Addendum No. 4

Date: February 28, 2012

PROJECT: Long Branch – George L. Catrambone Elementary School

CONTRACT No.: ET-0068-C01

4 SOUTH ELEVATION (REAR)
A-3.1 SCALE: 1/8"=1'-0"

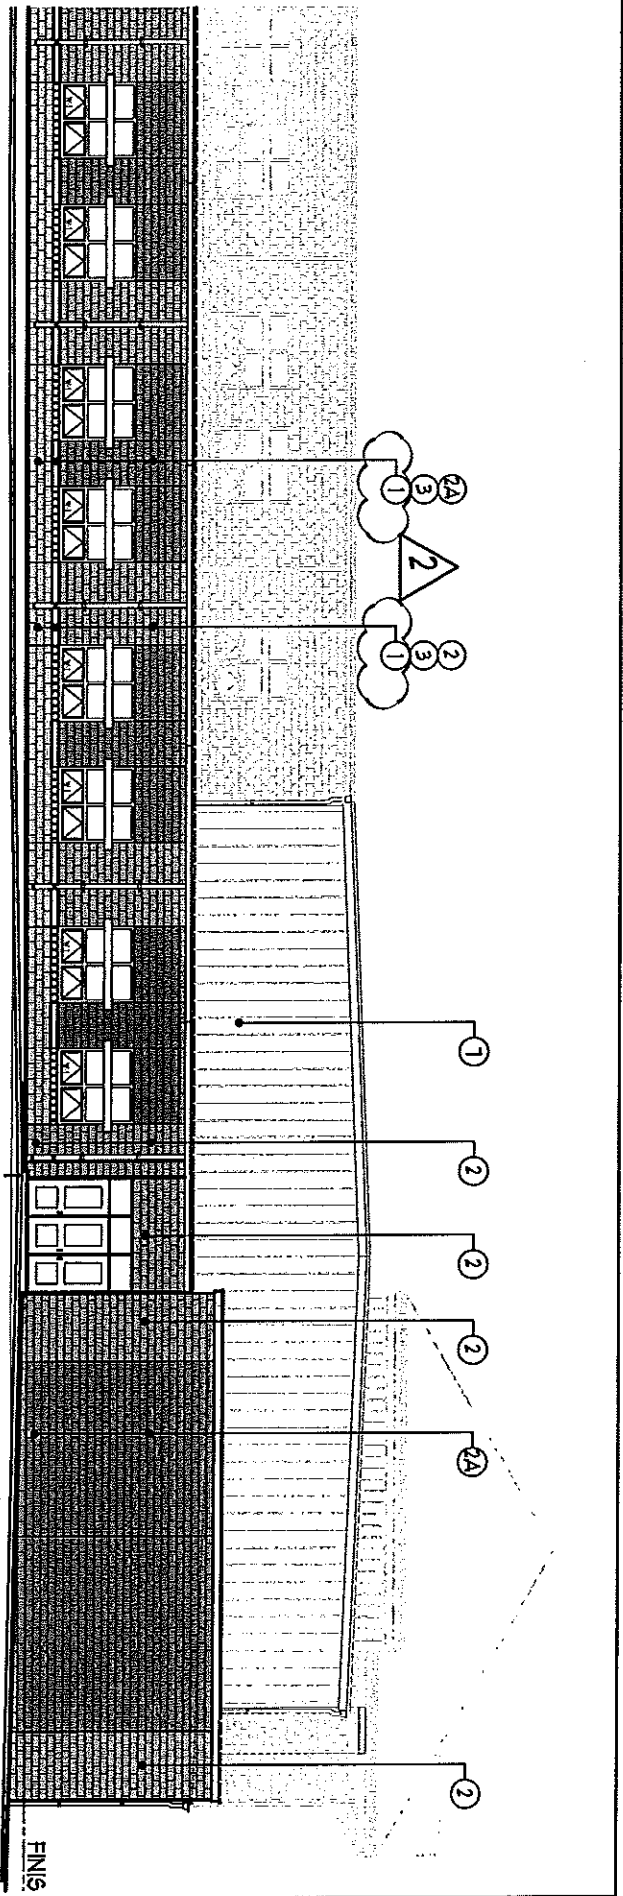
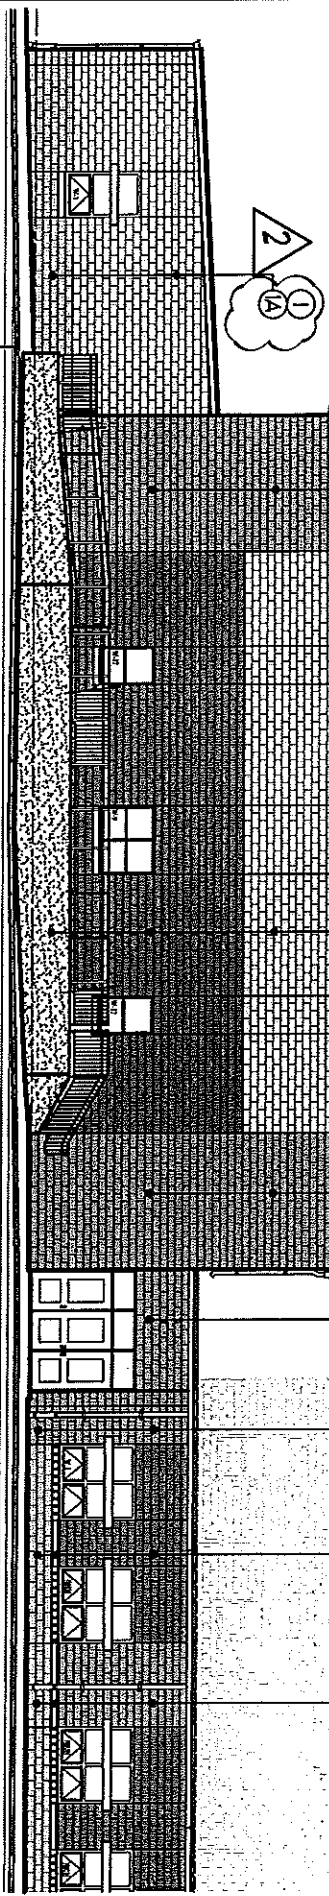
- Revise exterior material #1 to be #1A per SK-7.
 - Provide Cast Stone Window Sill at all Clerestory Windows per SK-7.
- Detail 4/A-3.1:
 - Revise exterior material #1 to be #1A per SK-8.

1 EAST ELEVATION
A-32 SCALE: 1/8" = 1'-0"

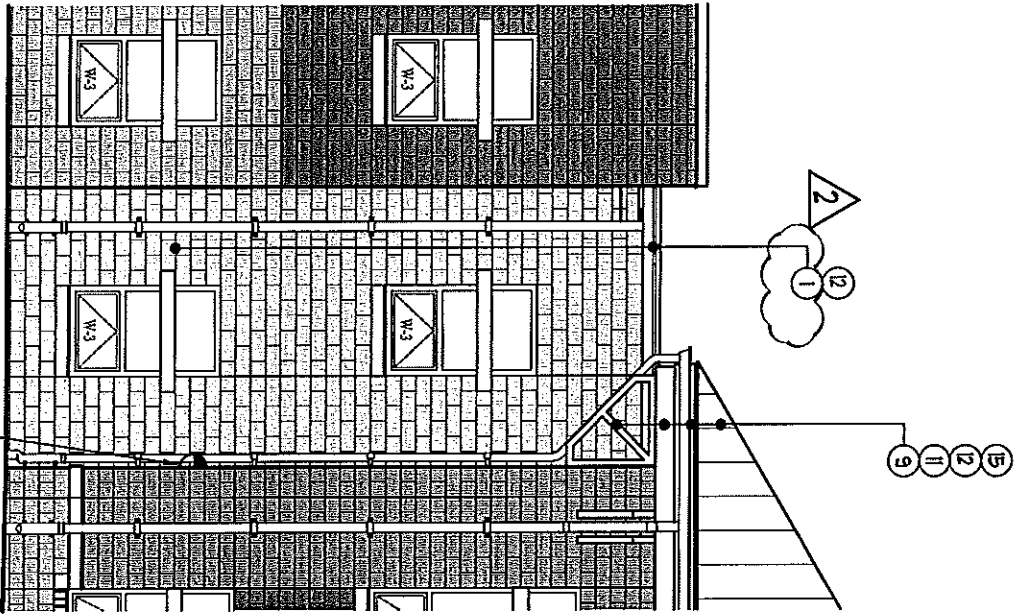
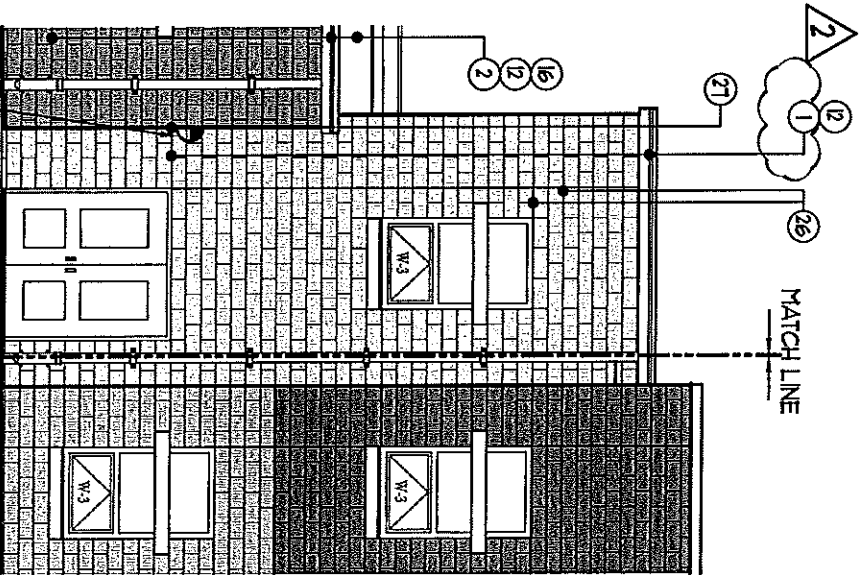
- Details 1/A-3.2 & 2/A-3.2:
 - Revise exterior material #1 to be #1A per drawing A-3.1 revisions and associated SK-5.
 - Revise exterior material #1A to be #1 per SK-9.

REFERENCED DRAWING
DETAIL/SHEET # 2 / A-4.4
DATE: 10-20-11

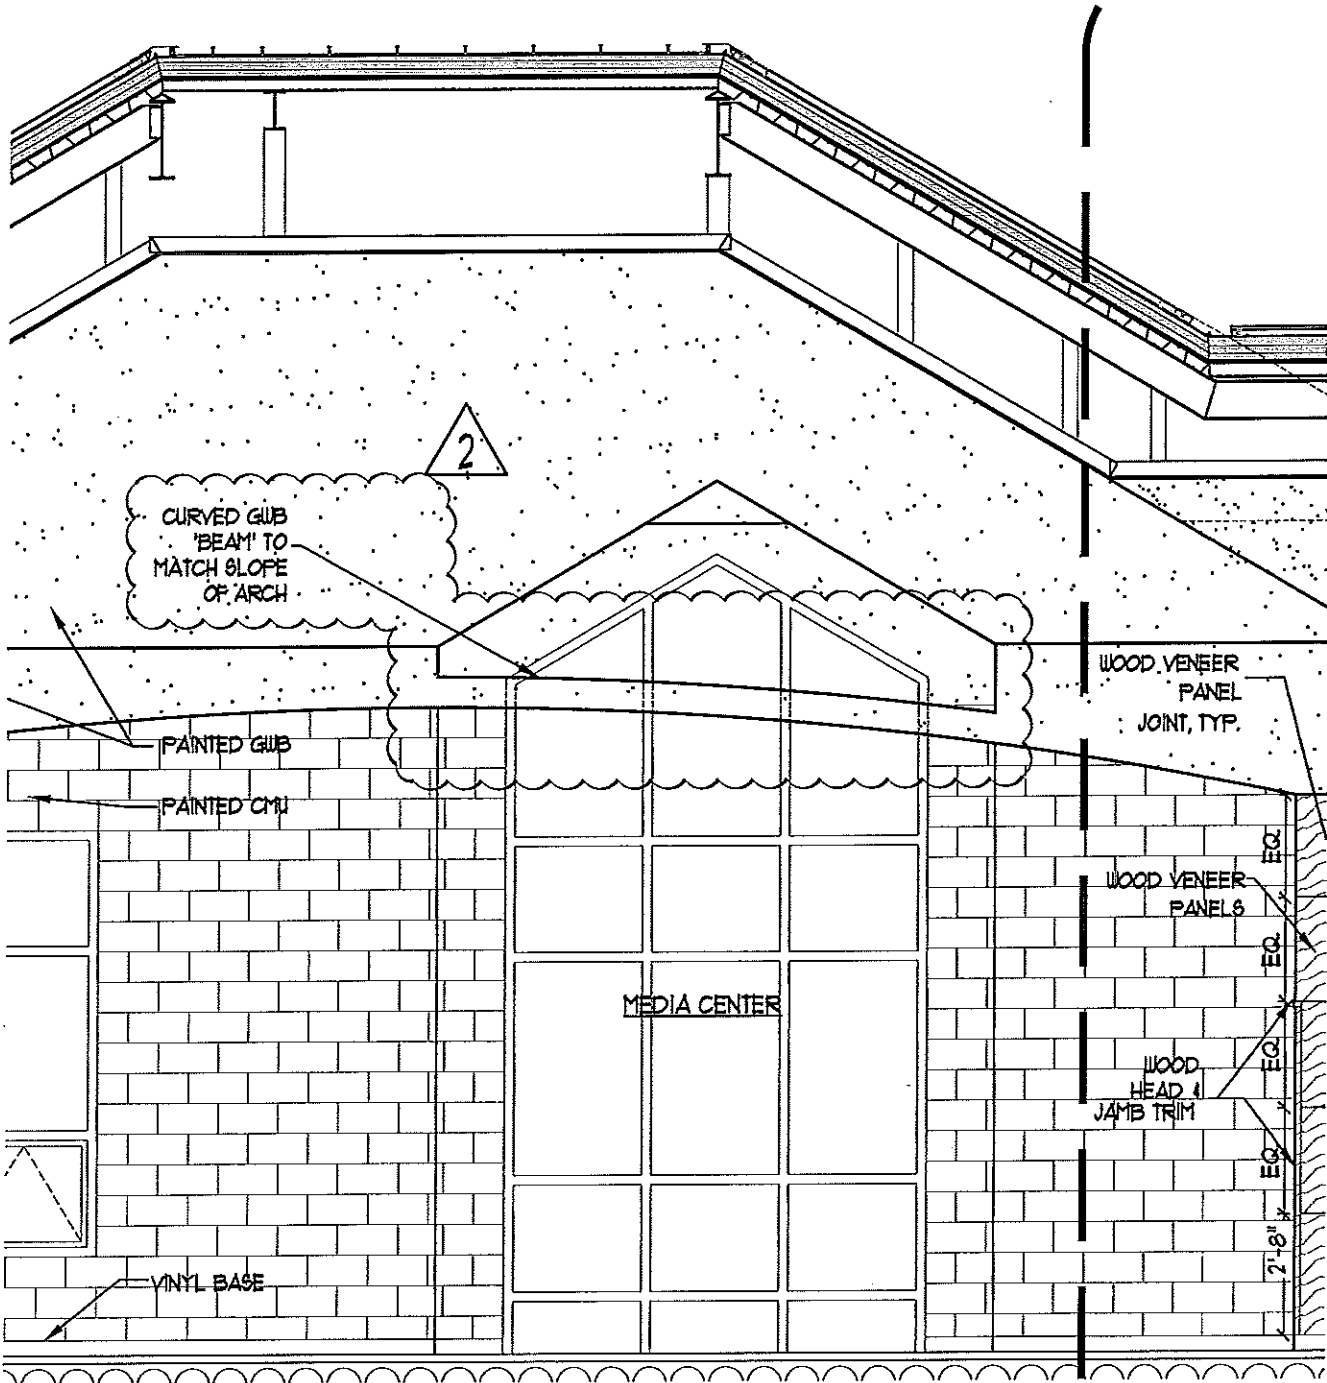
- Detail 1/A-4.4:
 - Replace term 'DESIGNATED' with 'DELEGATED' within note 'DESIGNATED DESIGN OF SECONDARY STEEL SUBFRAMING FOR CEILING AND UTILITY LOADS BY SPECIALTY ENGINEER, TYP.'
- Detail 2/A-4.4:
 - Revise detail to include curved gypsum wallboard 'beam' per SK-11.
- Detail 3/A-4.4:
 - Revise detail to include curved gypsum wallboard 'beam' per SK-12.
 - Revise interior wall finish note per SK-12.
 - Replace term 'DESIGNATED' with 'DELEGATED' within note 'DESIGNATED DESIGN OF SECONDARY STEEL SUBFRAMING FOR CEILING AND UTILITY LOADS BY SPECIALTY ENGINEER, TYP.'

REFERENCED DRAWING
DETAIL/SHEET # 2 / A-4.7
DATE: 10-20-11

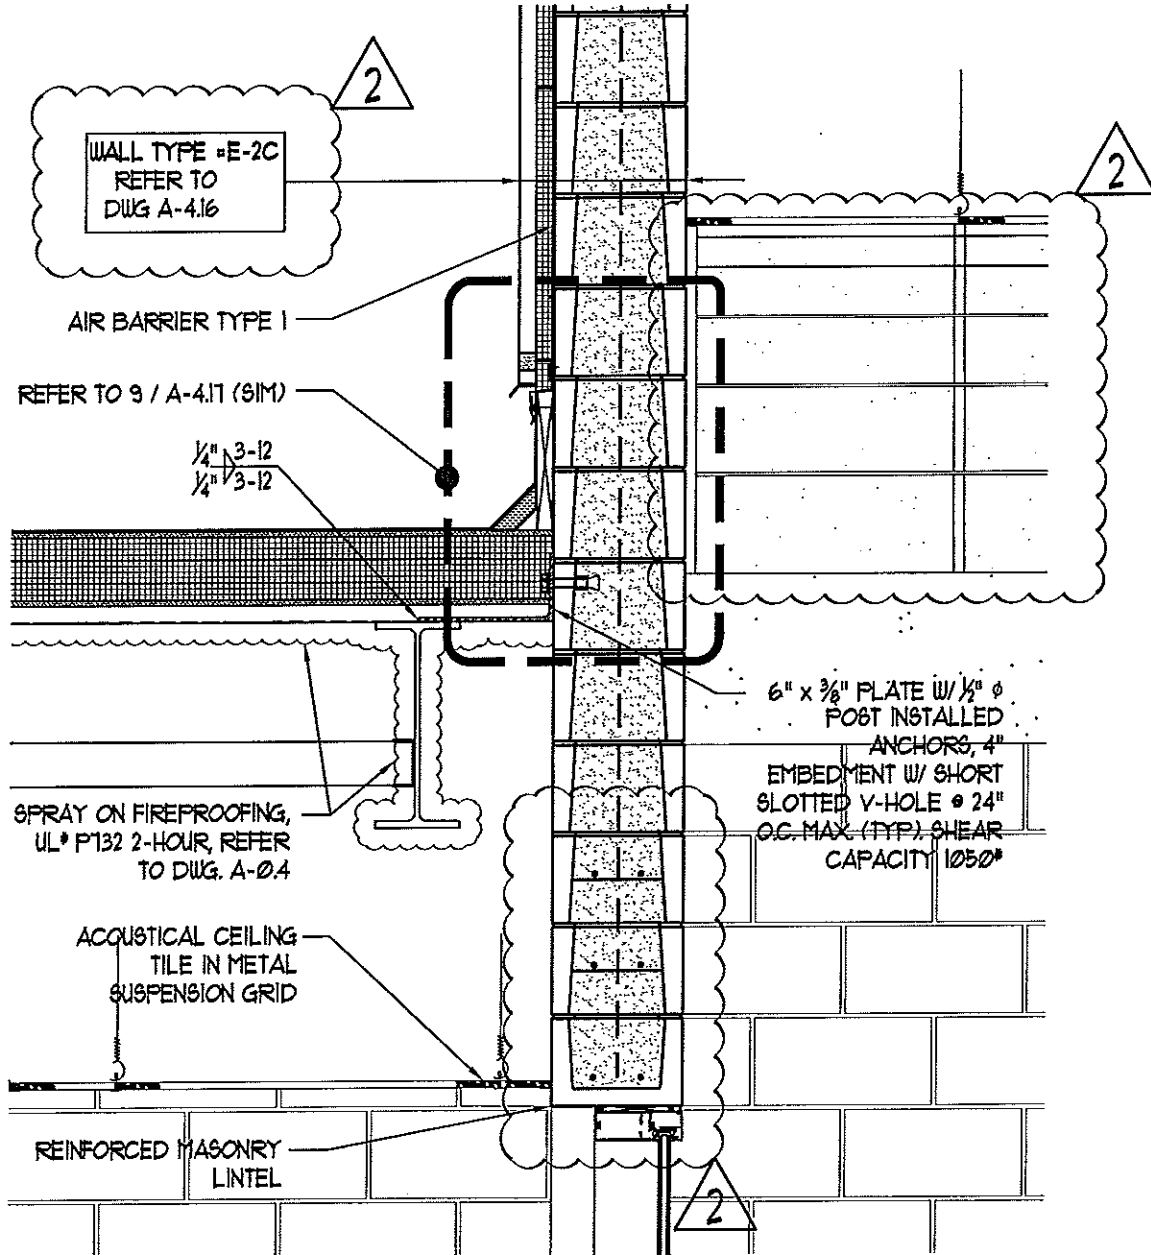
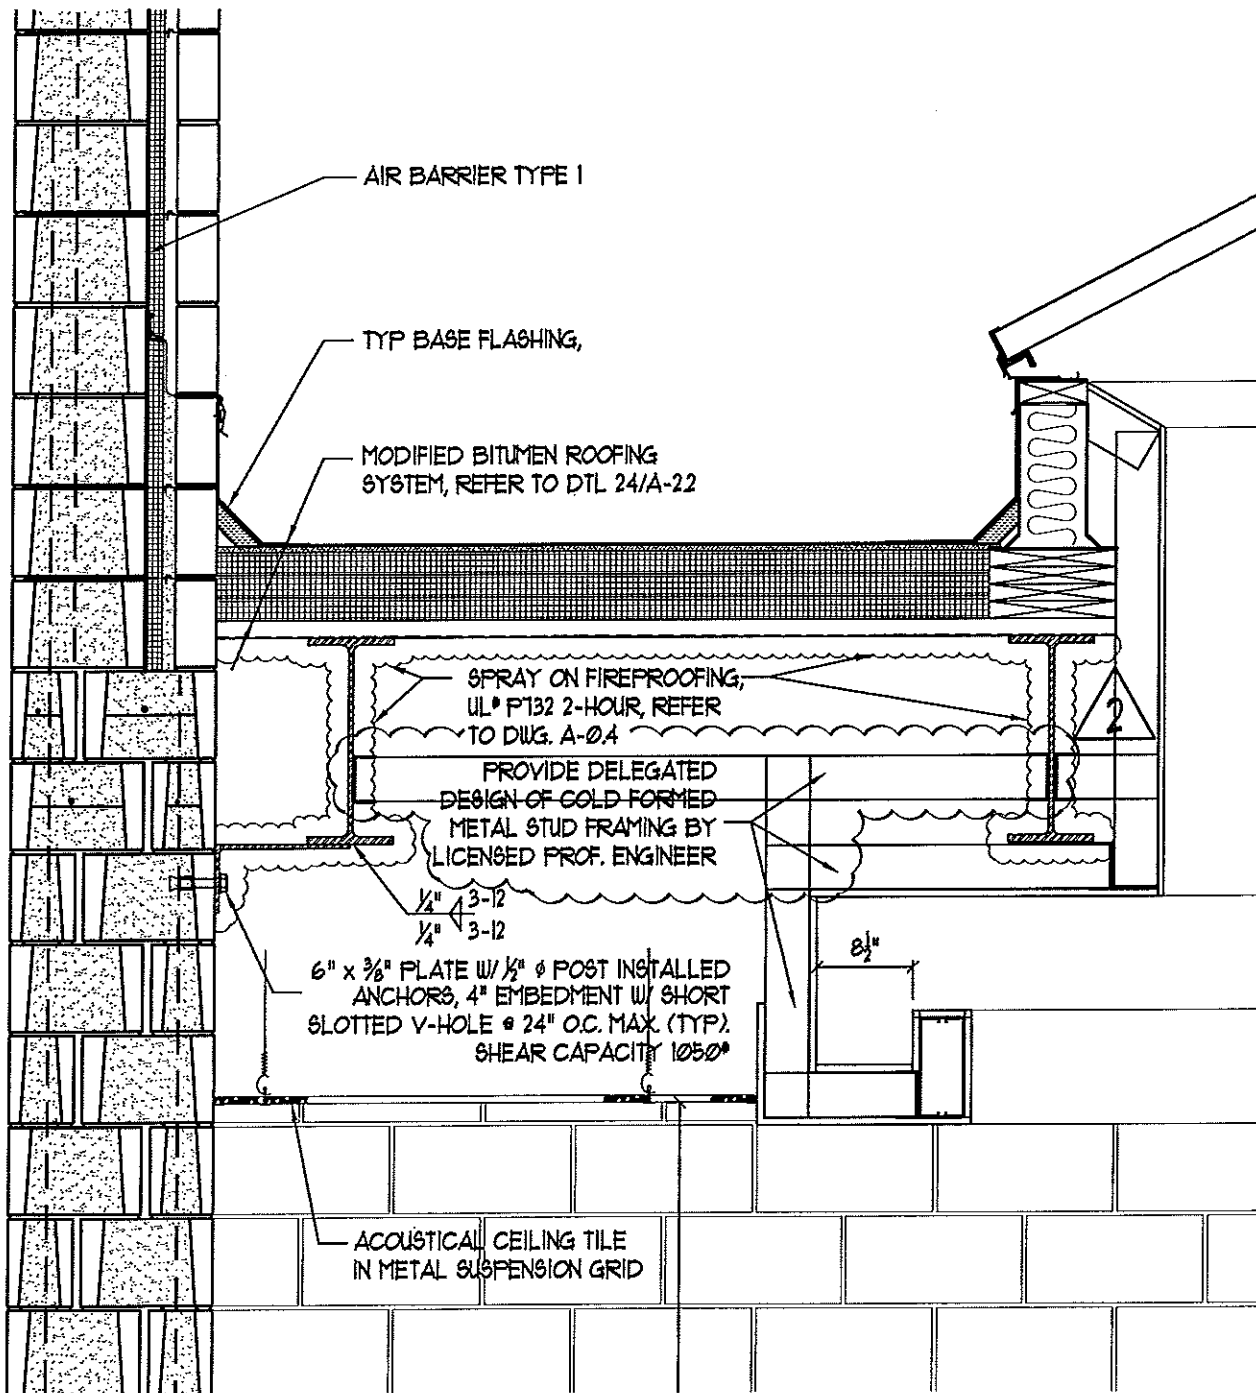
- Detail 1/A-4.7:
 - Revise referenced drawing detail at building parapet to be 'REFER TO DETAIL 2/A-2.1'
- Detail 2/A-4.7:
 - Revise referenced drawing detail at building parapet to be 'REFER TO DETAIL 2/A-2.1 (SIM)'
 - Revise detail to clarify note regarding requirement for Delegated Design of cold formed metal stud framing per SK-31.
- Detail 3/A-4.7:
 - Revise designation "Wall Type = E-2A" to "Wall Type = E-2C" per SK-16.
 - Revise masonry lintel as indicated.
 - Revise finished ceiling at Vestibule #160 per attached SK-16. Refer to SK-18 and SK-19.
- Detail 4/A-4.7:
 - Revise finished ceiling at Vestibule #160 per attached SK-17. Refer to SK-18 and SK-19.
 - Furnish and install ceiling access panel in Vestibule #160 per SK-17.

2 REFLECTED CEILING PLAN- BLOCK "D"
 A-72 SCALE: 1/8" = 1'-0"

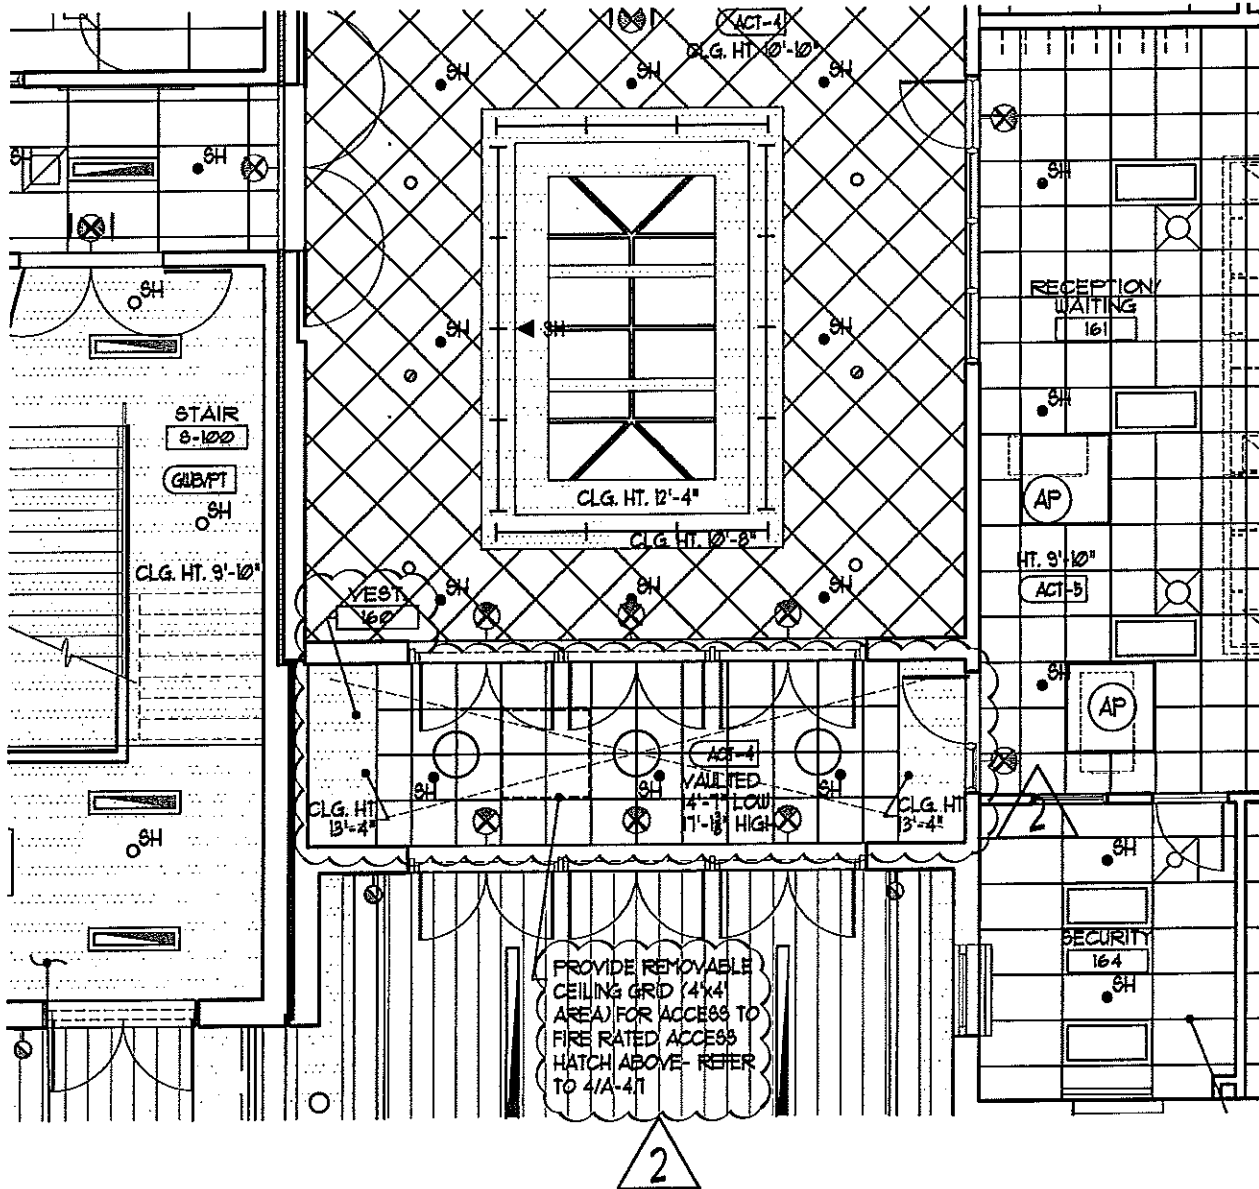
- Revise drawing 'LEGEND' per SK-32 (similar.)
- Detail 2/A-7.2:
 - Revise finished ceiling at Vestibule #160 per SK-19.
